**MEMORANDUM**

**REVIEW TYPE:** Preliminary Plan Review  
**APPLYING FOR:** Subdivision

**PROJECT NAME:** Property of Alban W. & Esther M. Eger  
**CASE #:** 120060490  
**REVIEW BASIS:** Chapter 50, Montgomery County Subdivision Regulations

**PRELIMINARY PLAN**

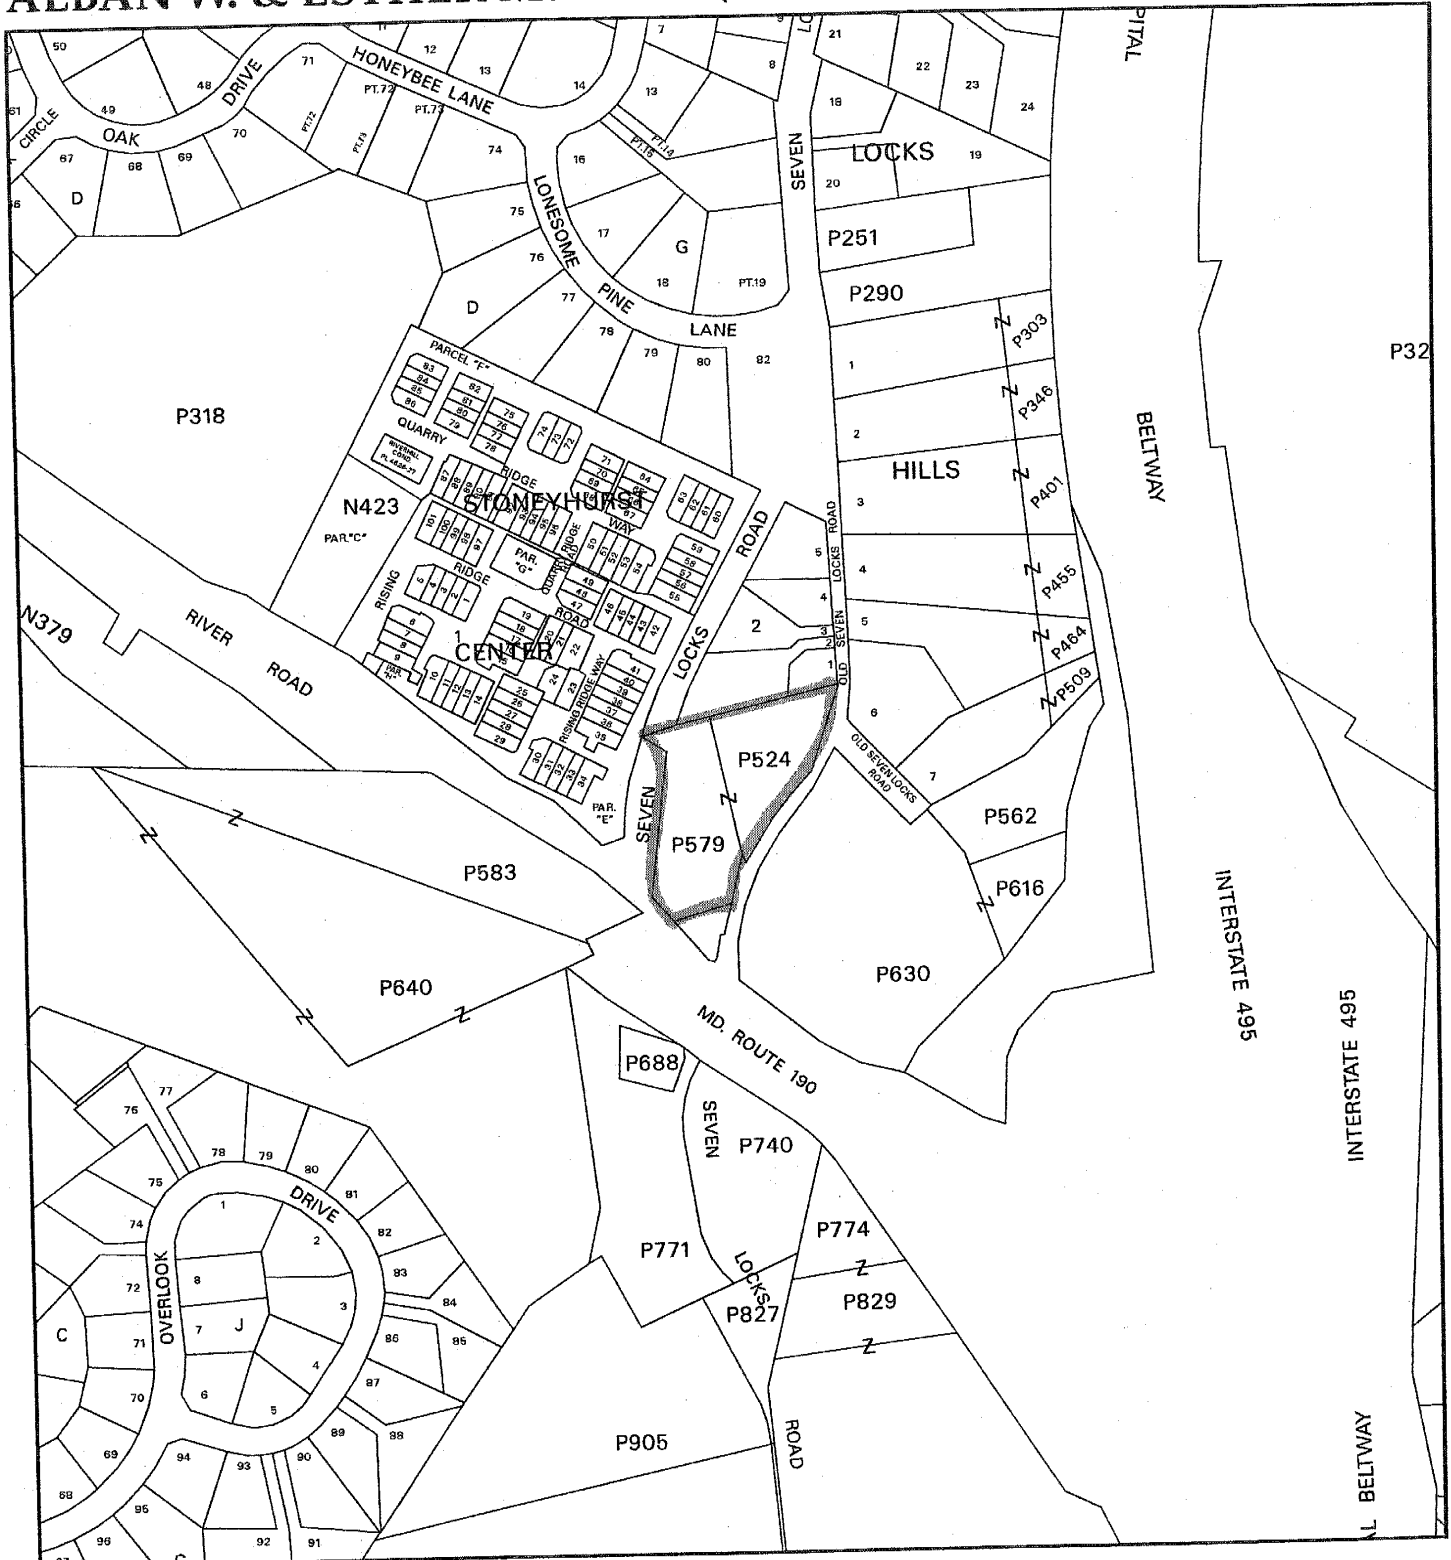
- 5) To ensure that the ridge heights of proposed houses will not exceed the first floor elevation of the historic Stoneyhurst House, the roof peak for the house on proposed Lot 2 shall not exceed elevation 207 feet, and the roof peak of the houses on proposed Lots 3 and 4 shall not exceed elevations 226 feet and 223 feet respectively.

The vista from Stoneyhurst to River Road is very important. As requested by the M-NCPPC Historic Preservation Staff, the preliminary plan has been modified and conditioned to reflect a ridge height limit to the new houses, which does not exceed the height of the first floor of Stoneyhurst House. Additionally, a Category II Conservation Easement will be placed on Lot 1 for protection of trees.

- The vista from Stoneyhurst to River Road is very important. The plan should reflect a ridge height limit of the new houses to not exceed the height of the first floor of Stoneyhurst.
- Retainment of the mature trees on the properties to maintain the forest between the historic house and River Road. Additionally, we would like to see a tree protection plan developed for the affected trees on the adjacent properties to ensure that these trees will not be adversely damaged by the new construction.

Staff supports the current development plan, which satisfies the requested modifications. The current plan submitted, revised 01/06, addresses the above height concerns by placing a roof peak height restriction on Lot 2. Additionally, the applicants have been working with the Environmental Planning staff on cross sections for the retaining walls to be installed between Lot 1 and Lots 2 and 3 to ensure the most minimal impact to the existing trees root systems.
